## **Proposal for Supplement 1 to the 05 series of amendments to Regulation No. 10 (Electromagnetic compatibility)**

The text reproduced below was prepared by the expert from the International Organization of Motor Vehicle Manufacturers (OICA), to propose amendments to ECE/TRANS/WP.29/2013/73. It supersedes GRE/2013/41. The modifications to document ECE/TRANS/WP.29/WP29/2013/73 are marked in bold for new or strikethrough for deleted characters

**"Figure 2  
Impedance of HV artificial network**

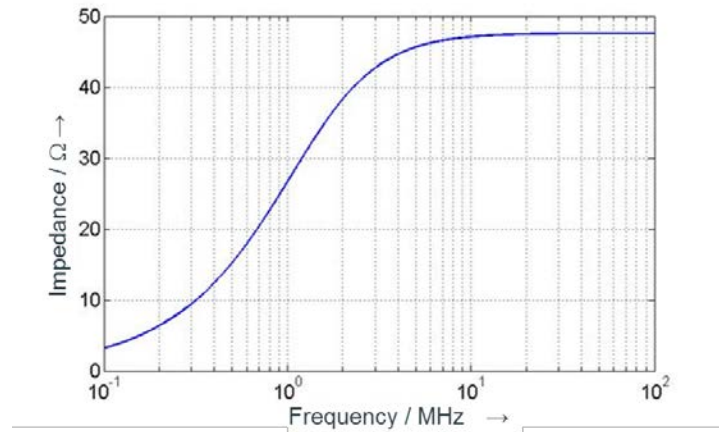
Appendix 8, figure 2, delete and replace by:

5. Appendix 8: The value of the resistor  $R_2$  shall be increased from 100 k $\Omega$  to 1 M $\Omega$  because, if the value of this resistor is too low, the isolation protection circuit of a tested high voltage device could be activated and switch off the high voltage system under test. Generally, REESS HV line isolated to the ground or vehicle body by 1M ohm or more to

reduce the touch current. R2: 100k ohm in HVAN (High Voltage Artificial Network) will cause some leakage of current from HV lines. A certain level of leakage current will activate the fail-safe function which shut down the HV lines between REESS and HV power module. R2: resistance to the ground earth should apply 1M ohm which is equivalent value to insulation resistance of HV lines of REESS. This HVAN is applied in ESA immunity function test. To confirm the immunity performance in ESA, HVAN should keep the equivalent insulation resistance condition to vehicle test.

6. Appendix 8, figure 2, HV artificial network: editorial correction, from German to English nomenclature.
7. Para. 7.15.2.2.: editorial correction; this clause should refer the ESA Annex.

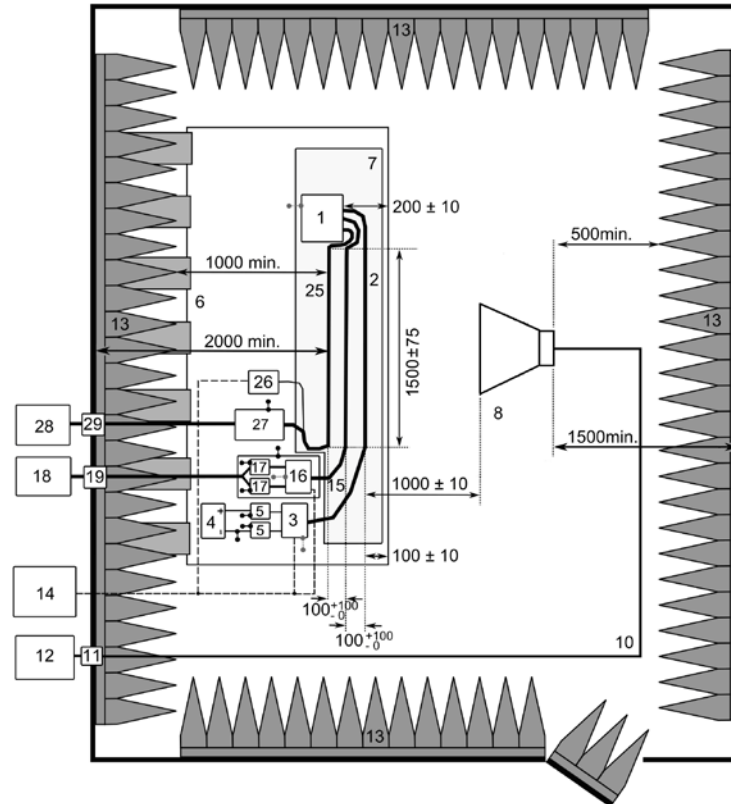
Annex 7, paragraph 4.4., amend to read:

~~The phase centre of the antenna for frequencies above 1'000 MHz shall be in line with the ESA."~~

11. Annex 7, para. 4.4.: editorial correction; an unnecessary sentence was deleted. Test frequency is below the 1000MHz.
12. Annex 9, Appendix 3: Figure had to be improved because vertical polarization is applied in this regulation. Vertical layout figure should thus be applied in this annex. In vertical layout figures, a horn antenna figure would be better and easier for recognizing the antenna polarization compared with bi-conical antenna in figures.

"Figure 1

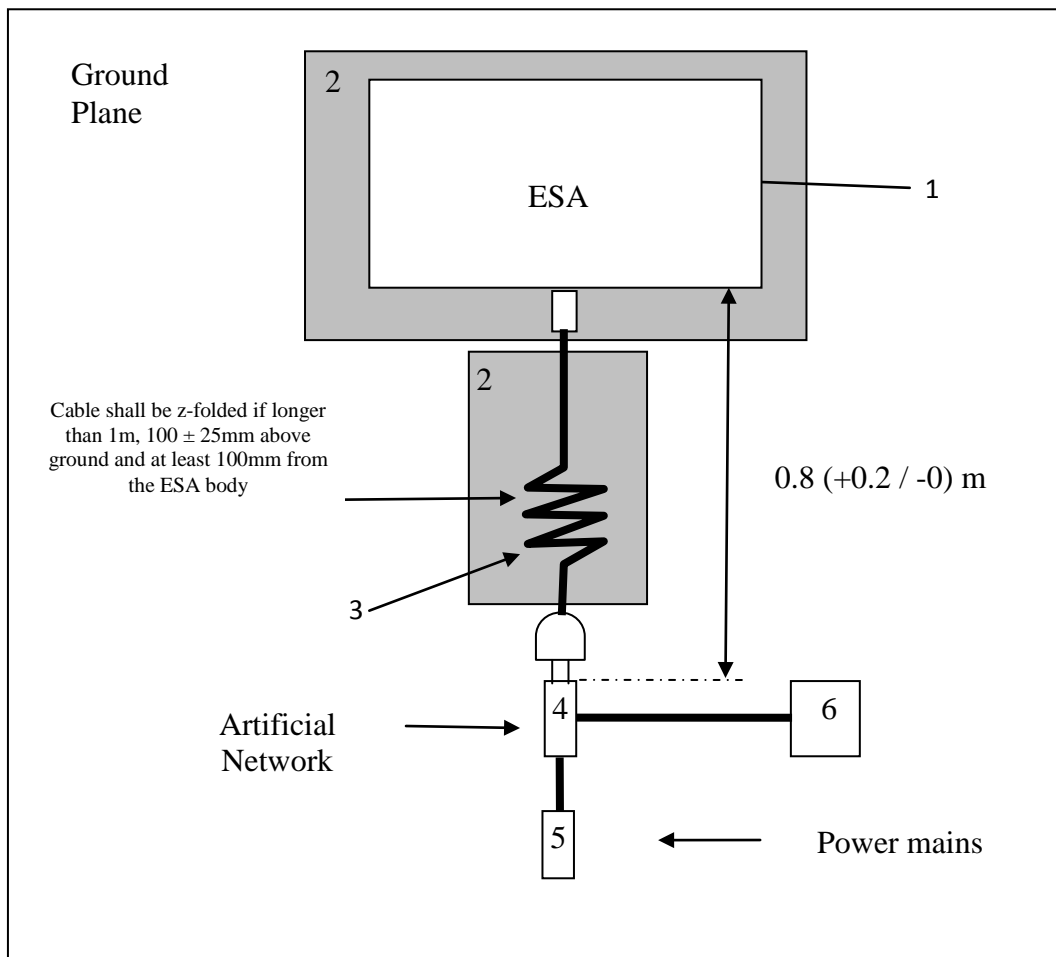
*Annex 19, Appendix, Figure 1, amend to read:*

ESA in configuration "REESS charging mode coupled to the power grid"

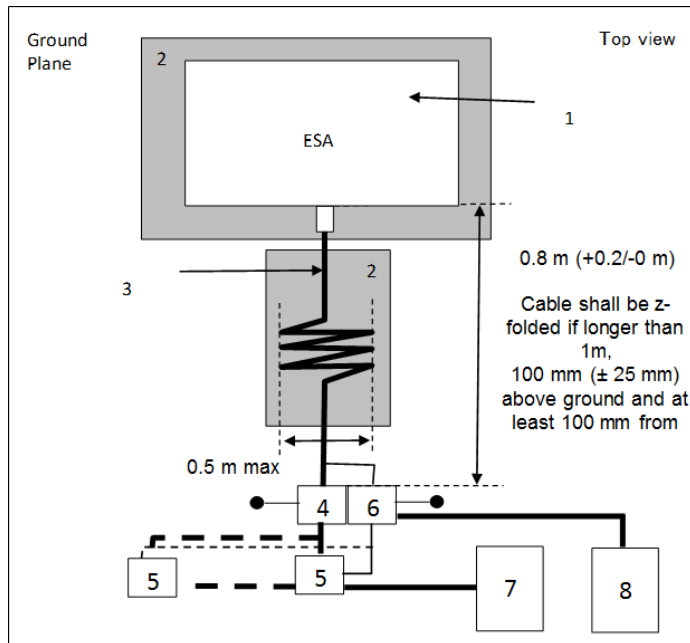
Annex 20, Appendix, Figure 1, delete and replace by:

- 1 ESA under test
- 2 Insulating support
- 3 Charging / communication cable
- 4 AC or DC Artificial Network(s) grounded
- 5 Power mains socket
- 6 Impedance Stabilization(s) grounded
- 7 Charging Station
- 8 Measuring receiver**

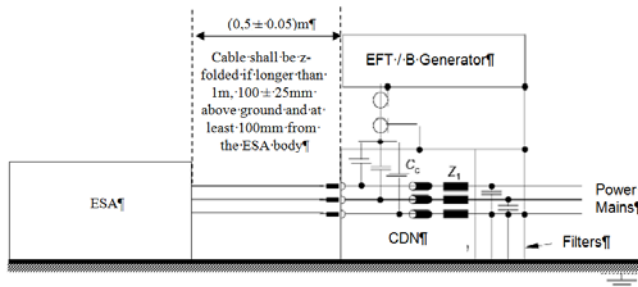
Annex 21, Appendix, Figure 1, delete and replace by:

- "Legend
- 1 — ESA under test
  - 2 — Insulating support
  - 3 — Charging / communication cable
  - 4 — AC or DC Artificial Network(s) grounded
  - 5 — Power mains socket
  - 6 — Impedance Stabilization(s) grounded
  - 7 — Charging Station"

**"Figure 1**  
**ESA in configuration "REESS charging mode coupled to the power grid" - Coupling**  
**between lines for DC or AC (single phase) power lines.**

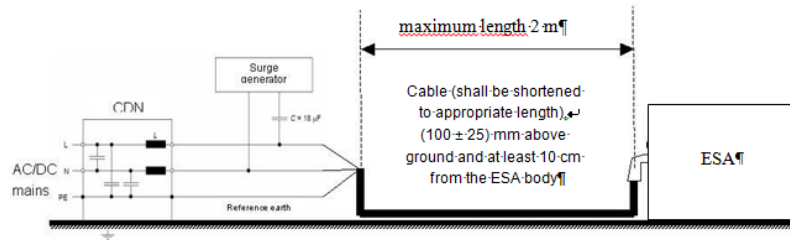
Annex 22, Appendix, Figures 1-4, amend to read:
